UNITED STATES PATENT AND TRADEMARK OFFICE

APPLICATION NO.	FILING DATE	FIRST NAMED INVENTOR	ATTORNEY DOCKET NO.	CONFIRMATION NO.
10/629,243	07/28/2003	Lawrence D. Knox	02103-377003 / AABOSS14-C	6582
26162	7590	08/29/2006	EXAMINER	
FISH & RICHARDSON PC P.O. BOX 1022 MINNEAPOLIS, MN 55440-1022			CULBRETH, ERIC D	
			ART UNIT	PAPER NUMBER
			3616	
DATE MAILED: 08/29/2006

Office Action Summary	Application No. 10/629,243	Applicant(s) KNOX ET AL.	
	Examiner Eric Culbreth	Art Unit 3616

FIG. 2A

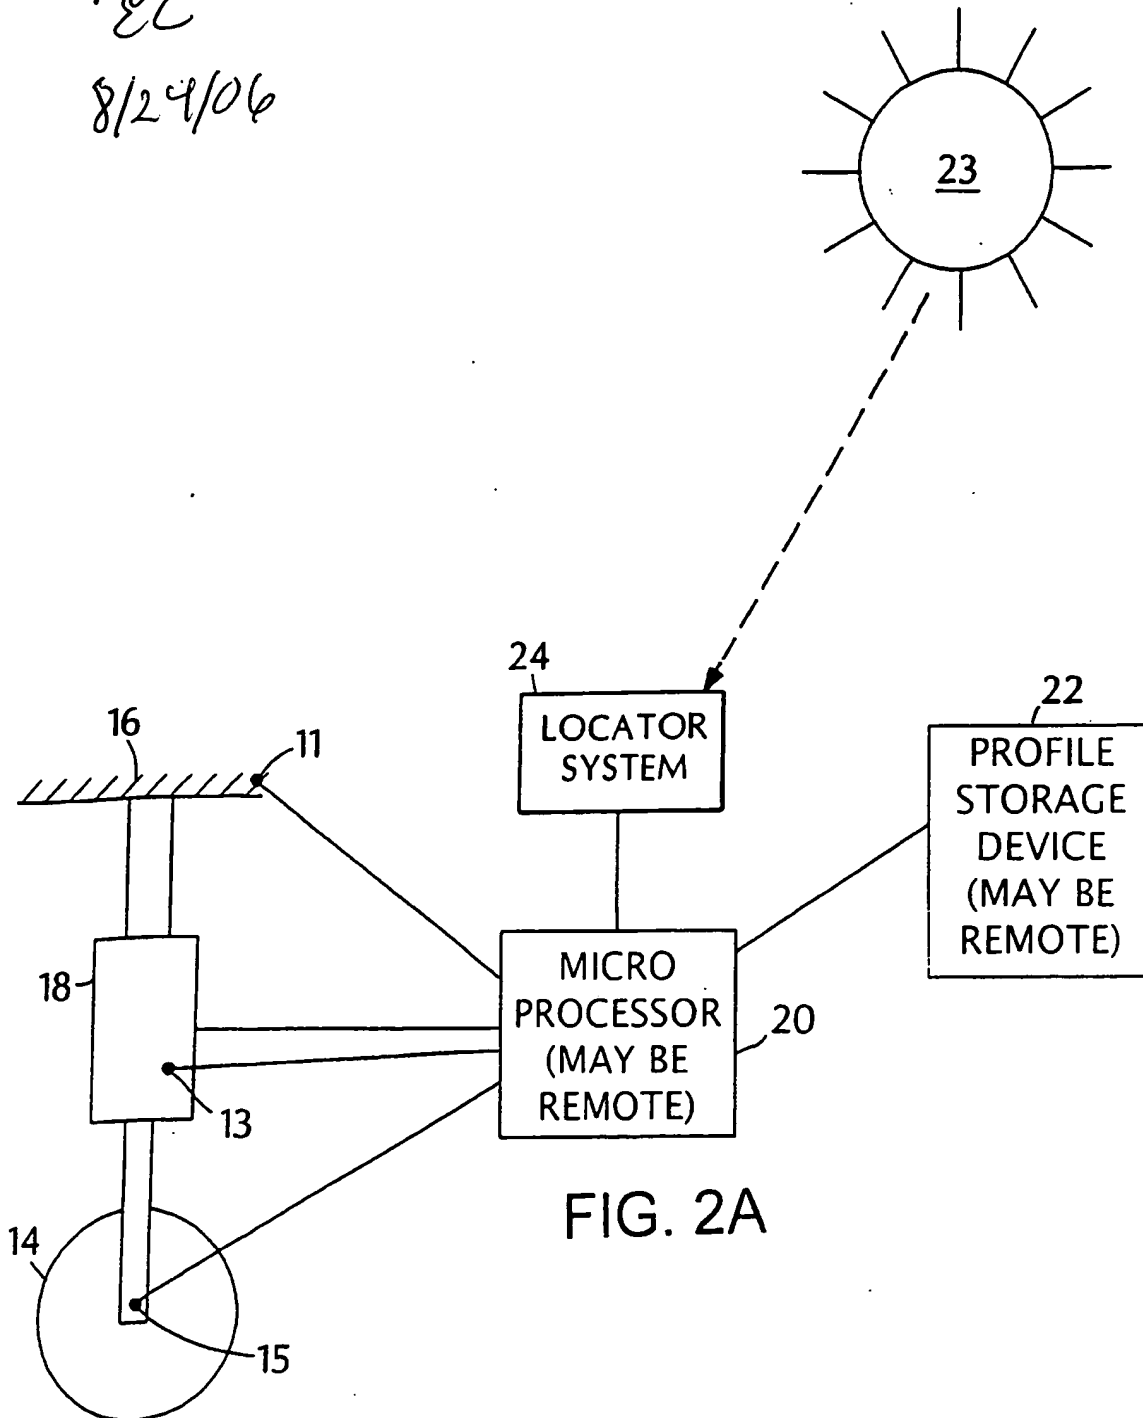
1. Upon reconsideration, as claims 8-9 and 23-26 depend from allowed claims, and in view of applicant's cited text on page 12, line 9 that the device of Figure 2a and Figure 2b could be in the same embodiment, these claims are no longer withdrawn.

4. The drawings are objected to under 37 CFR 1.83(a). The drawings must show every feature of the invention specified in the claims. Therefore, the features of claim 6 in combination with the features of claims 8-9 and the features of claim 20 in combination with the features of claims 23-26 must be shown or the feature(s) canceled from the claim(s). No new matter should be entered. (Although page 12 of the specification discloses the profile and trajectory plan storage files, microprocessor(s), etc. can be used in the same embodiment, they are not illustrated as claimed in the same figure or embodiment.)

Corrected drawing sheets in compliance with 37 CFR 1.121(d) are required in reply to the Office action to avoid abandonment of the application. Any amended replacement drawing sheet should include all of the figures appearing on the immediate prior version of the sheet, even if only one figure is being amended. The figure or figure number of an amended drawing should not be labeled as "amended." If a drawing figure is to be canceled, the appropriate figure must be removed from the replacement sheet, and where necessary, the remaining figures must be renumbered and appropriate changes made to the brief description of the several views of the drawings for consistency. Additional replacement sheets may be necessary to show the renumbering of the remaining figures. Each drawing sheet submitted after the filing date of an application must be labeled in the top margin as either "Replacement Sheet" or "New Sheet" pursuant to 37 CFR 1.121(d). If the changes are not accepted by the examiner, the applicant will be notified and informed of any required corrective action in the next Office action. The objection to the drawings will not be held in abeyance.
